UNITED STATES PATENT AND TRADEMARK OFFICE

Office Action Summary

10/084,608

KOMA, NORIO

Fig. 4

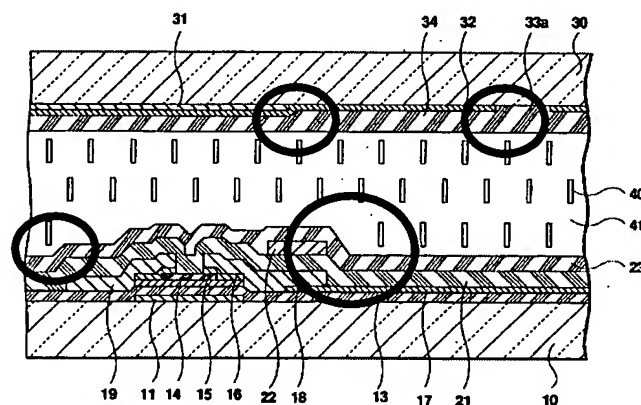
4. Regarding claims 15-16, Koma discloses the vertically aligned LCD as recited above, however, the reference fails to specifically disclose orientation controllers (23, 34; see circled areas in the reproduced figure below for convenience) with sloped projections extending along the longer edge of the electrode region and branching at both longitudinal ends of a corresponding one of the electrode regions toward the corner section of the electrode (23, 34; see circled areas).
